**A. ADMINISTRATIVE SITE PLAN REPORT & DECISION**

<b>REPORT DATE:</b>	December 8, 2016
<b>Project Name:</b>	Copperwood ADUs
<b>Owner:</b>	Quadrant Homes; 15900 SE Eastgate Way, Bellevue, WA 98008
<b>Applicant/Contact:</b>	Razvan Mosu, Quadrant Homes; 15900 SE Eastgate Way, Bellevue, WA 98008
<b>File Number:</b>	LUA16-000717, CU-A
<b>Project Manager:</b>	Angelea Weihs, Assistant Planner
<b>Project Summary:</b>	The applicant submitted an application for a Conditional Use Permit for the construction of two new Accessory Dwelling Units (ADUs) on two lots (lot 45 and lot 37) within Copperwood Plat. The subject lots are located at 252 and 326 Graham Ave SE. Lot 45 is 5,946 square feet and lot 37 is 5,264 square feet. Both lots are within the Residential-4 Zone (R-4). New single family homes are proposed on both lots. Access to both ADUs would be provided via existing shared driveways abutting each lot. There are no critical areas on site.
<b>Project Location:</b>	326 & 252 Graham Ave SE

**SUBJECT:** Copperwood Accessory Dwelling Units  
326 and 252 Graham Ave SE  
LUA16 000717

**EXHIBIT 2**

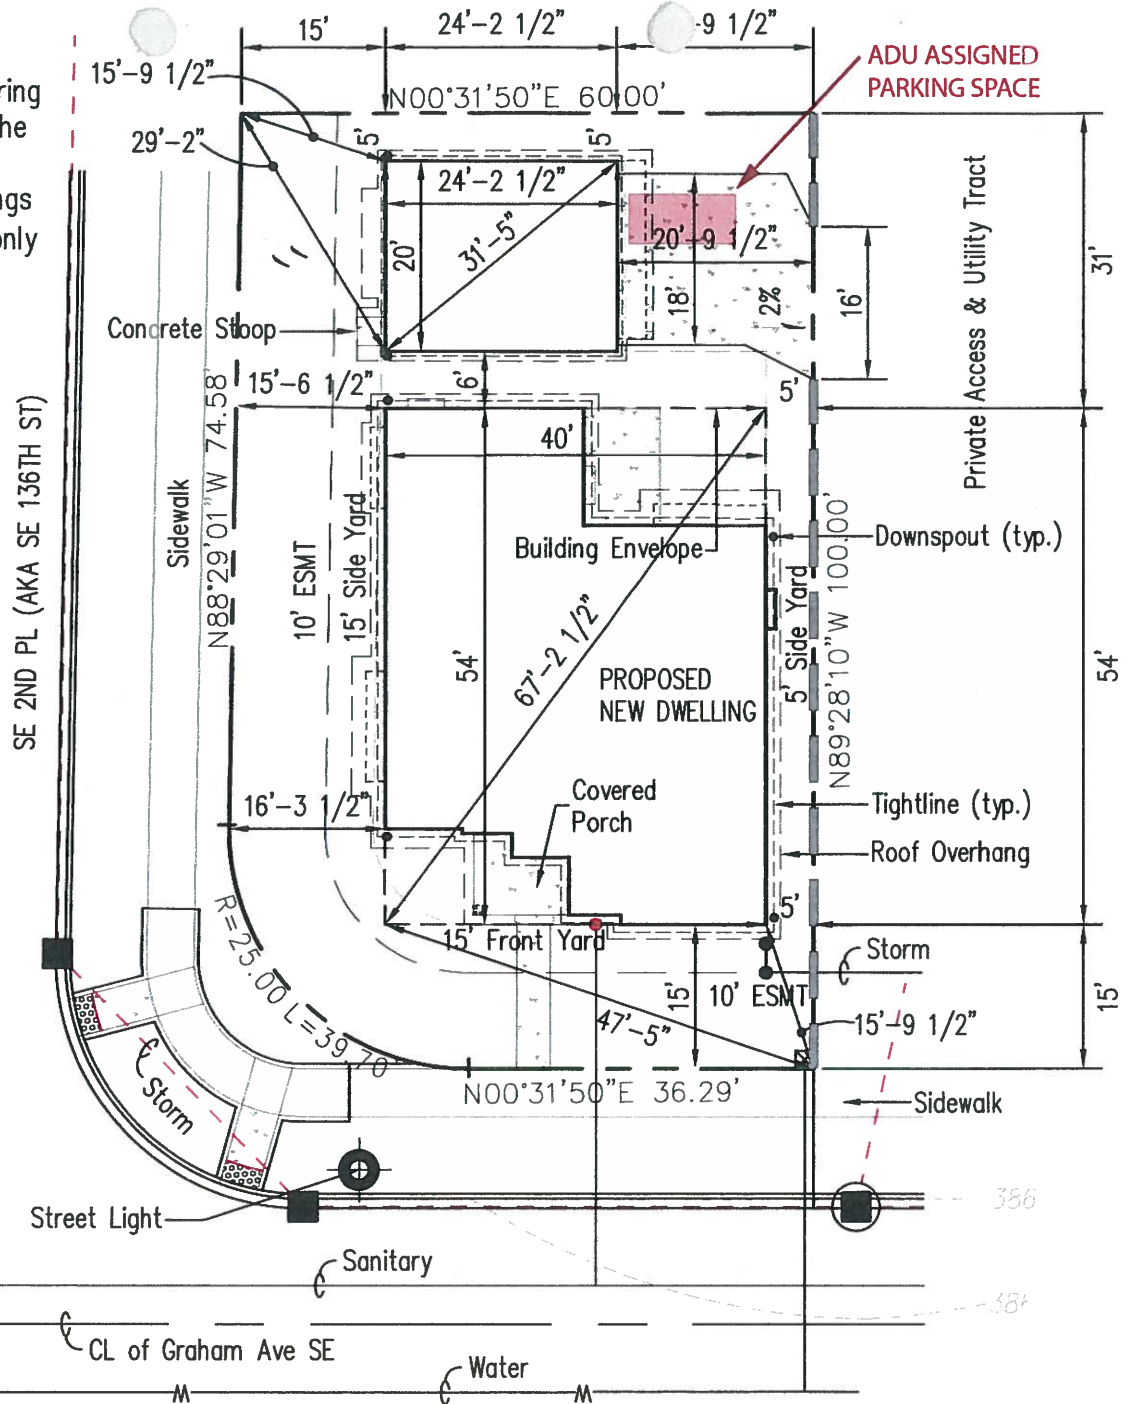
✓	<p><b>e. Parking:</b> Adequate parking is, or will be made, available.</p> <p><u><b>Staff Comment:</b></u> See Parking discussion under FOF 15, Parking.</p>
<b>Compliant if condition of approval is met</b>	<p><b>f. Traffic:</b> The use shall ensure safe movement for vehicles and pedestrians and shall mitigate potential effects on the surrounding area.</p> <p><u><b>Staff Comment:</b></u> Vehicular access to both ADUs would be provided via two existing shared driveways extending from Graham Ave SE. Access to lot 45 is proposed via the existing shared driveway to the south of the lot, and access to lot 37 is proposed via the existing shared driveway to the north of the lot. No change to traffic and circulation patterns of vehicles and pedestrians relating to the proposed ADUs and surrounding area are anticipated. The Copperwood community includes a two-way looped street that connects twice to SE 2<sup>nd</sup> Pl. The two lots have access to Graham Ave SE via shared driveways, for easy access to the development. Since Graham Ave SE is not a through street, traffic shall be minimal, created only by residents and visitors to the community. Sidewalks built within the community, including Graham Ave SE, will ensure safe pedestrian movement within the community and to the proposed ADUs. Lot 45 is a corner lot, with sidewalks on both street frontages. No pedestrian connection is proposed from the sidewalk to the ADU entrance. Staff recommends, as a condition of approval, that a minimum three foot (3') wide pathway be installed from SE 2<sup>nd</sup> Pl to the ADU entrance. A revised site plan and landscape plan showing the new pedestrian pathway shall be submitted with the building permit application.</p>

1. The applicant shall provide a minimum three foot (3') wide pedestrian path from SE 2<sup>nd</sup> PI to the front door (north elevation) of the proposed ADU on lot 45. A revised site and landscape plan shall be submitted, and approved by, the Current Planning Project Manager prior to building permit approval.
